# Development Review Division

**SUBJECT:** SUB20-002, Douglas 234 Filing 5 – Minor Development Plat Review Comments v1

SKETCH/PRELIMINARY PLAN FOR  
**CHAMBERS & HESS**  
FILING NO. 1  
DOUGLAS COUNTY, COLORADO

**TITLE SHEET**

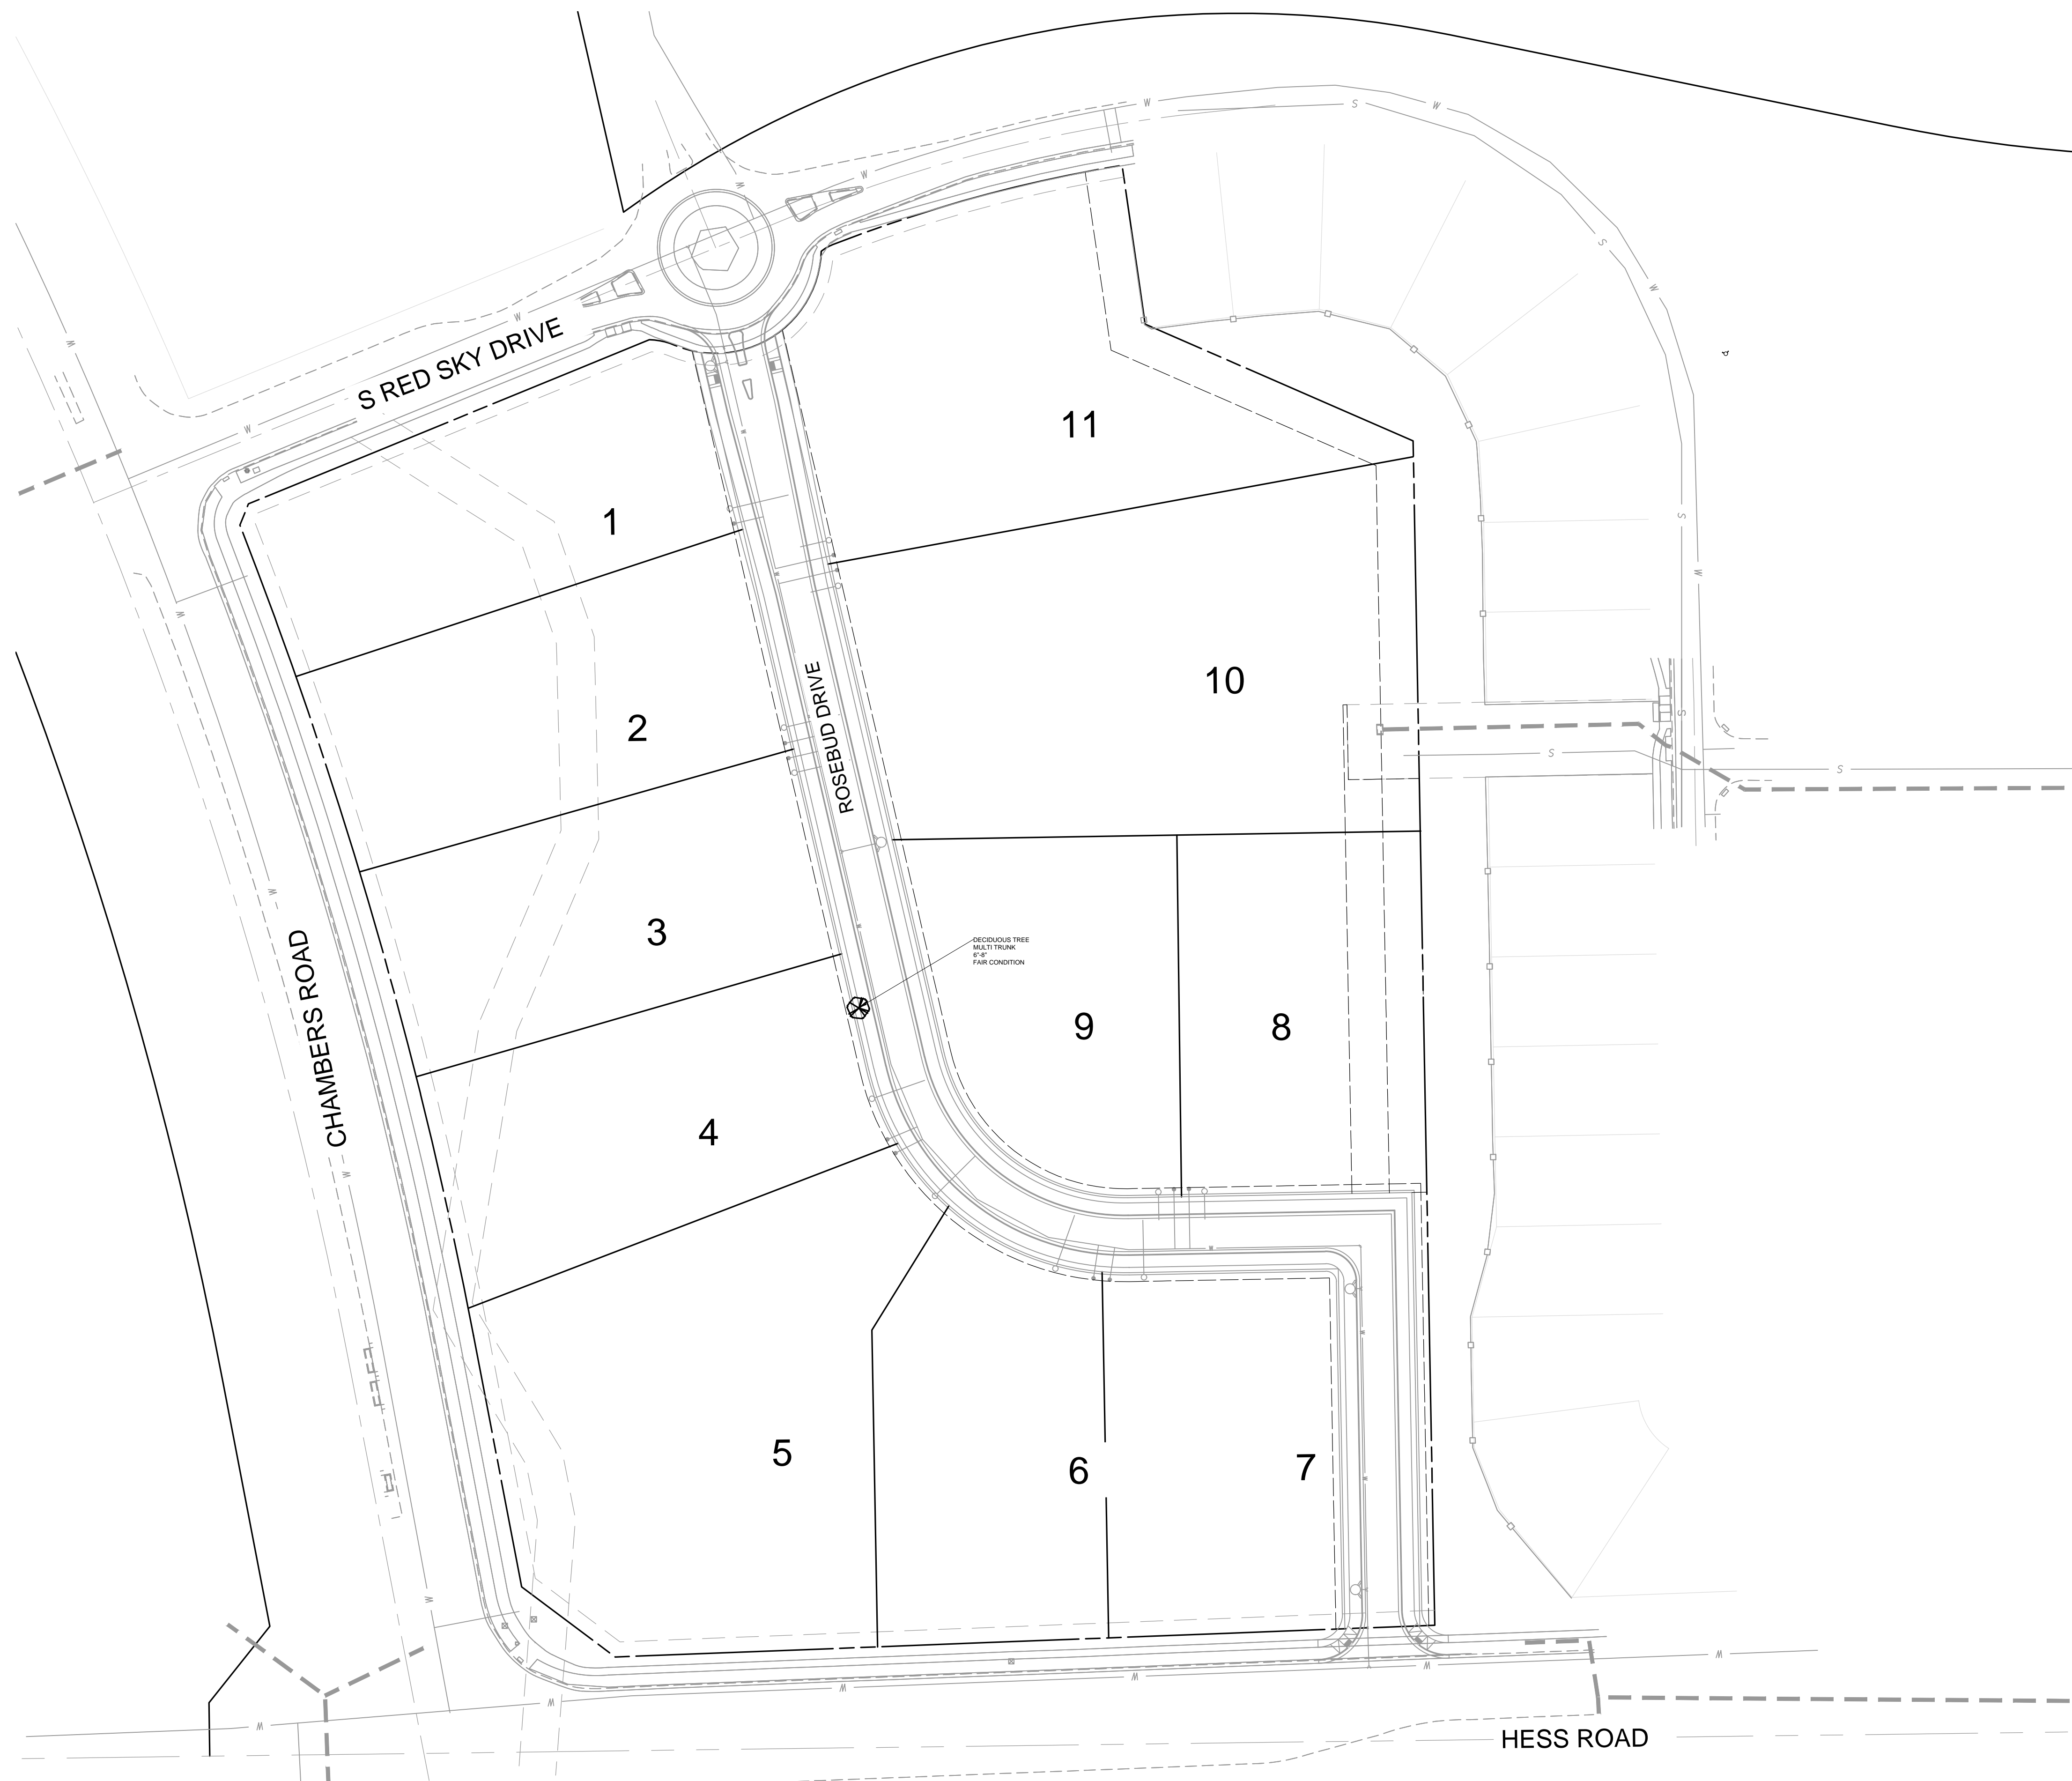
Please separate out the Minor Development Plat from the CD's. This should include page one and three of this document. Please note all comments found on page one and three should be reflected in the proposed Minor Development Plat. Please review Section 13.07.100(f) of the Land Development Ordinance to ensure all requirements for the exhibits have been met.

Update plat name to "Douglas 234 Filing 5" on all pages.

Remove the legend, abbreviation, and plan sheet index for the Minor Development Plat.

Remove these two sections for the Minor Development Plat.

The 5 mandatory plat notes for commercial subdivisions must be added. Please see the notes attached to the comment letter.

Please add all signatures as outlined in Section 13.07.130 some of these include:  
- Acknowledgment  
- Deed of Trust  
- Title Verification  
- Town Council Certificate  
- Planning Commission Certificate  
- Surveyor's Certificate  
- Clerk and Recorder's Certificate  
Please add the dedication statement word for word as outlined in Section 13.07.130(h).

## LANDSCAPE TABLE

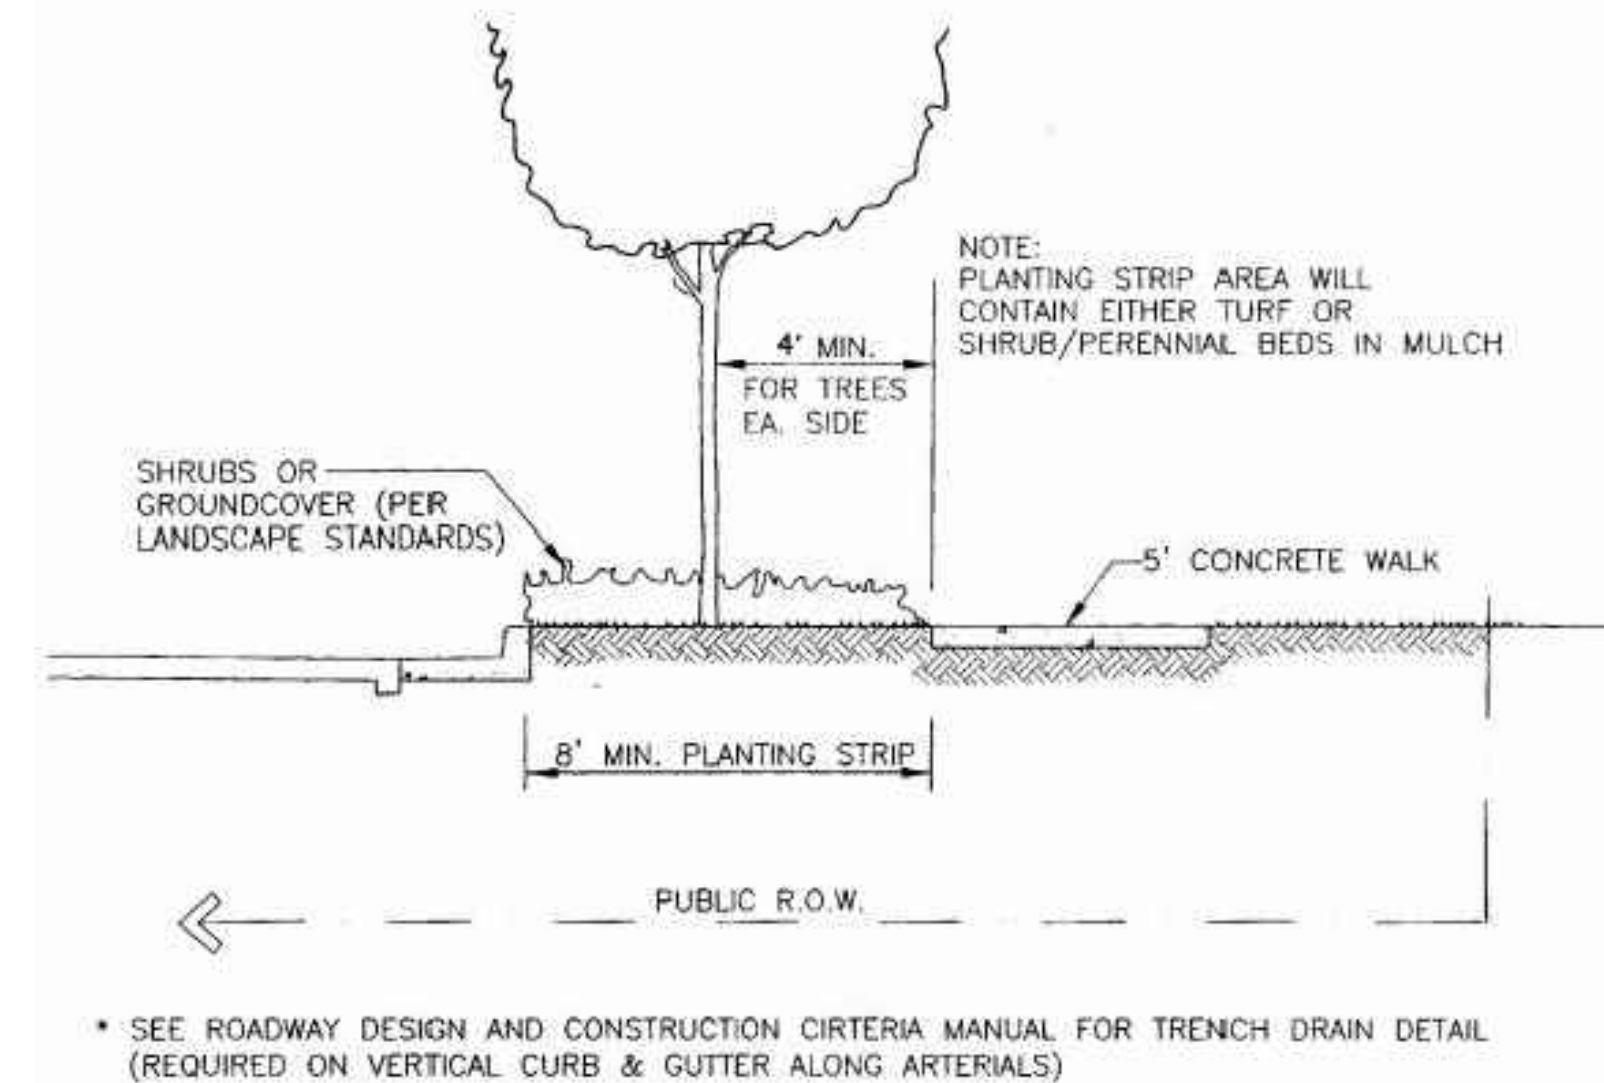
Please provide a table to show the streetscape requirements outlined in Section 13.06.070(m) of one tree per 40 linear feet is met.

Per Section 13.060.070(g) the landscape buffer should be the commercial site perimeter adjacent to residential requirements of 1 tree and 5 shrubs for each 25 linear feet of edge. Please update the landscape and table accordingly.

Please provide the species height.

Per the Construction Specifications and Design Considerations for Parks, Trails and Streetscapes the two identified species are located on the Prohibited Species list (page 79). Please adjust accordingly on all pages of the master landscape plan.

## LANDSCAPE NOTES & DETAILS

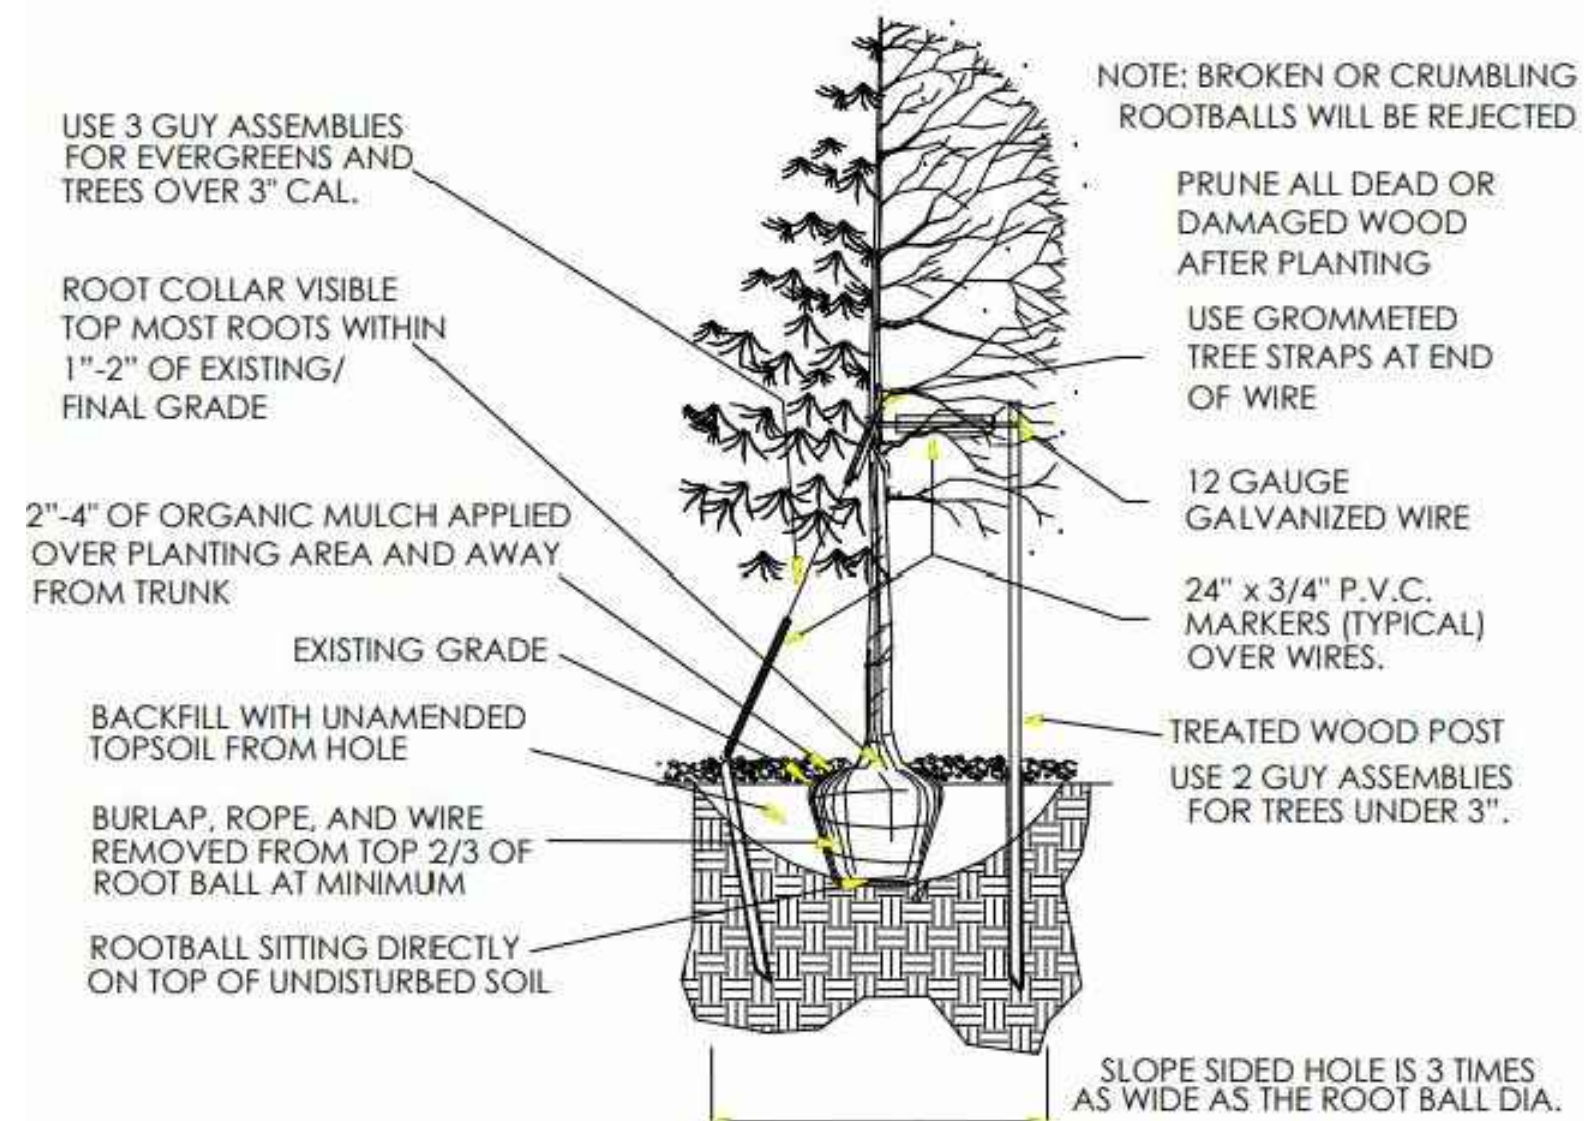
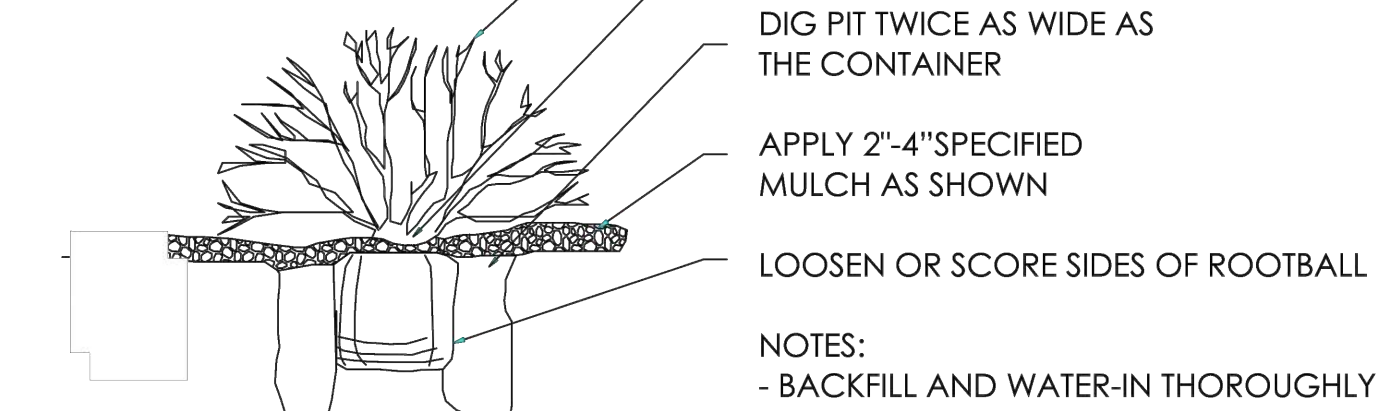
Per Section 13.06.070(o) for commercial parking lots adjacent to residential zones the buffer shall include plant material of a minimum of four (4) feet in height intended to buffer the view of parked cars and reduce the impact of headlights on nearby development. This buffer shall also include screening materials shall provide a minimum opacity of seventy-five percent (75%) during the summer months.

Even though we do not know the layout of each commercial lot at this time, it is good practice to meet this standard to prevent impacts from vehicles navigating the commercial lots as they develop.
